February 29, 2024

Re: Division Adequacy Review No. 2; Technical Revision 141 (TR-141) Grassy Valley Monitoring Well Installation – Phase 1, Permit No. M-1980-244

REPORT ON EAST CRESSON OVERBURDEN STORAGE AREA ACID ROCK DRAINAGE SUSTAINABLE SOLUTIONS EVALUATIONS; CRIPPLE CREEK & VICTOR MINE

Figure
1

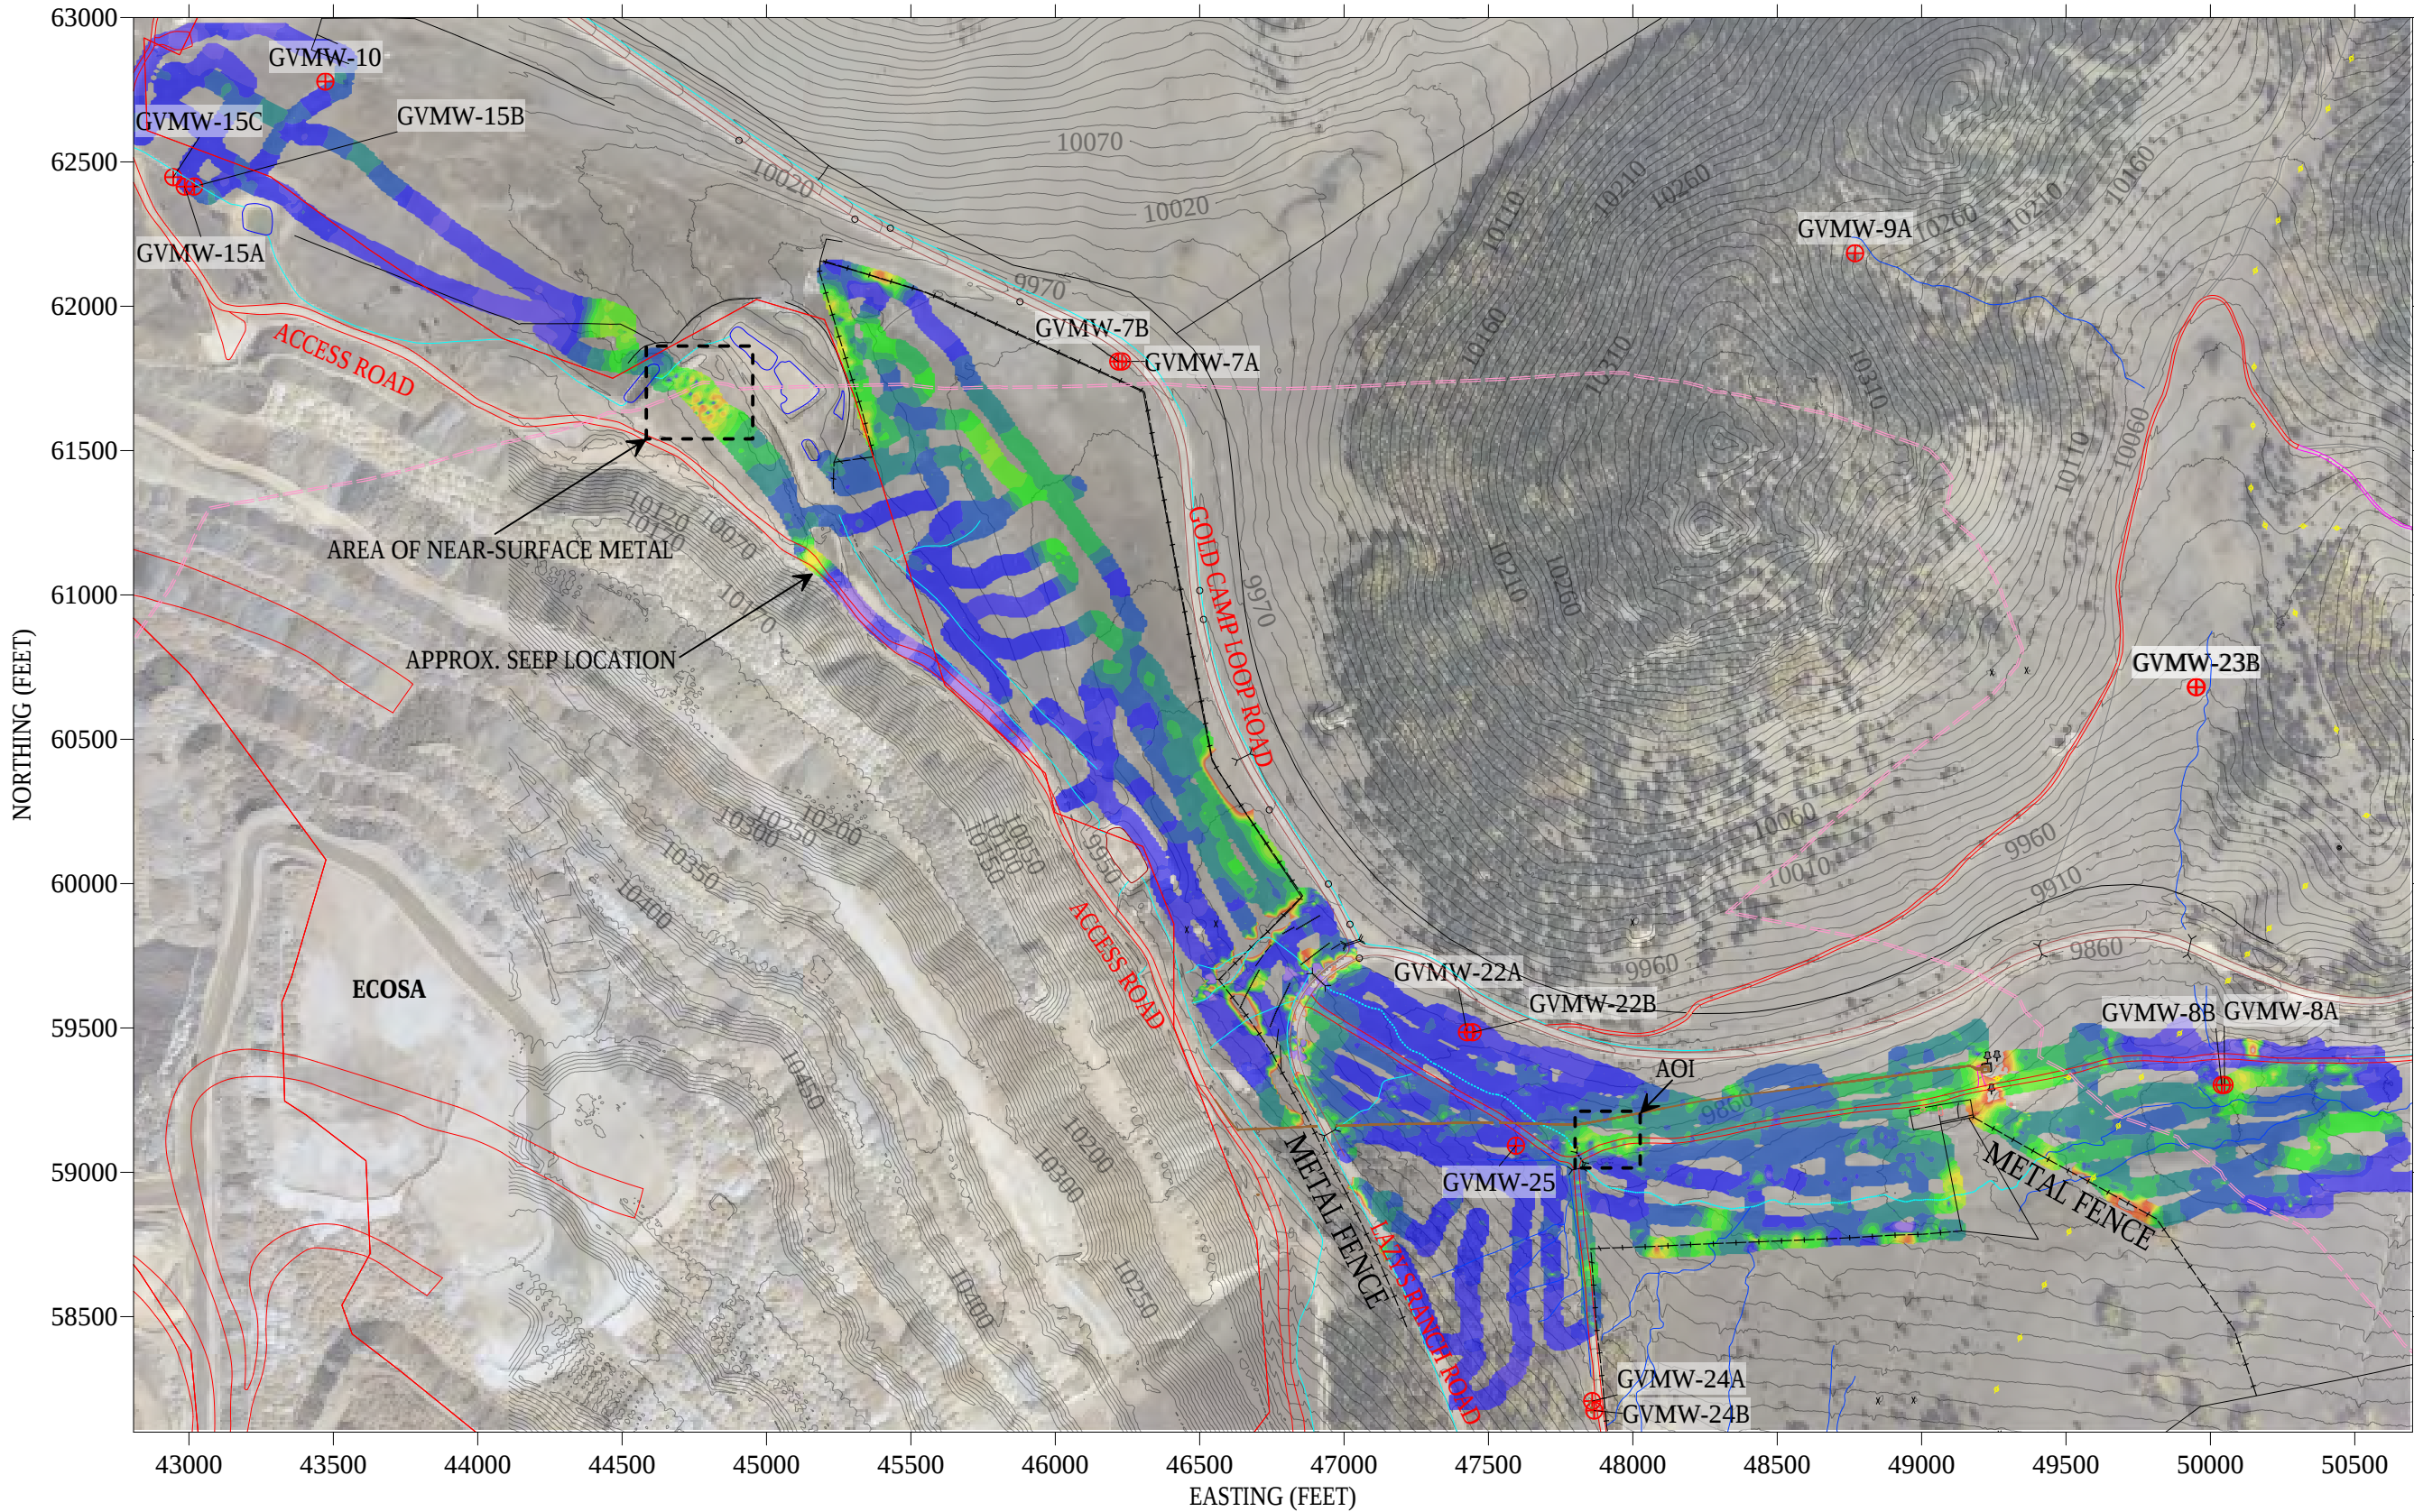
- 1. Provide an explanation why there were no resistivity survey transects performed further down in Grassy Valley as depicted in Figure 1 of the Golder report.**

Multiple Electrical Resistivity Imaging (ERI) transects were performed in Lower Grassy Valley during an investigation by WSP Golder in August 2022; however, the primary focus of the geophysical investigations was to identify potential seepage pathways between ECOSA and GVMW-25 in order to determine where mitigation could be merited to prevent further migration. The follow up geophysical survey targeted this area along the toe of ECOSA to further define the source. The WSP Golder "Report on East Cresson Overburden Storage Area Acid Rock Drainage Sustainable Solutions Evaluations" is included in Attachment 1. The results from this investigation do not conclusively indicate a preferred flow path of seepage between the ECOSA and GVMW-25 or other Grassy Valley monitoring wells.

Attachment 2

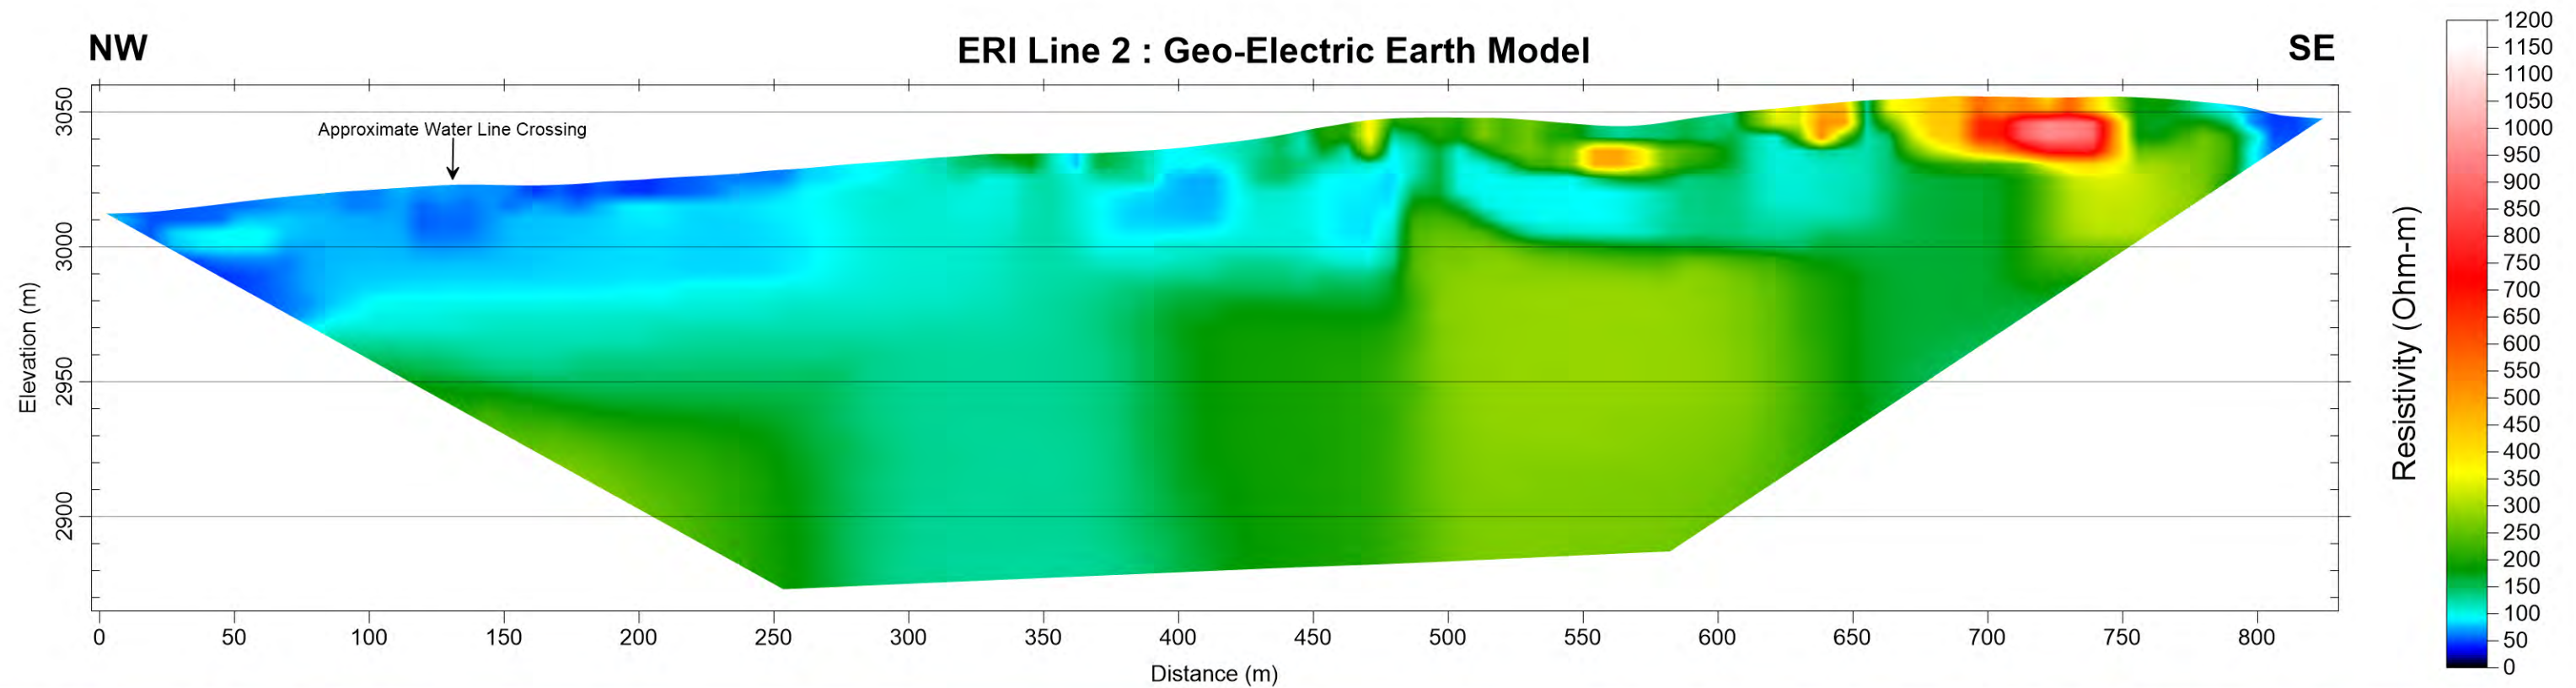
- 6. The cross-sections given in Attachment 2 does not show a clear distinction between colluvial and bedrock material, is there a way to define the depth to bedrock through the surveys?**

- 7. In the last figure, Attachment 2, there is an area of low resistivity shown in the SE section (800 m) portion of the transect. Why is this section not being investigated further?**

- 8. Revise the last figure of Attachment 2 to project the locations of GVMW-24A/B, OSABH-12 and GVMW-25 on to it.**

Bedrock is typically associated with higher resistivity values (warm colors of yellow, orange, & red) which can be interpreted to represent intact rock with little pore water at depth. In this instance it is difficult to conclusively define the depth to bedrock from the survey. Due to the uncertainty in the hydrogeologic setting of colluvial and shallow bedrock, the bore hole logs from the installation of the proposed monitoring wells will be used to characterize the subsurface conditions.

CC&V's primary focus for investigation and mitigation are potential seepage pathways downgradient of the ECOSA that could be leading to the observed impacts at GVMW-25. The location at 800m on Attachment 2 is not evaluated to be in the hydrogeological path between the ECOSA facility and receiving groundwater system. This location is approximately 1,500 feet laterally to the south of the ECOSA facility with no mine facilities hydrogeologically upgradient of the location.. The proposed monitoring well locations were selected to better characterize the subsurface immediately adjacent to the ECOSA and potentially intercept shallow groundwater prior to migration downgradient into Grassy Valley.

Attachment 2 contains the revised figure with the projected locations of GVMW-25, GVMW-24A/B, and OSABH-12. Please note that the figure is not to scale, and the well locations are approximate.
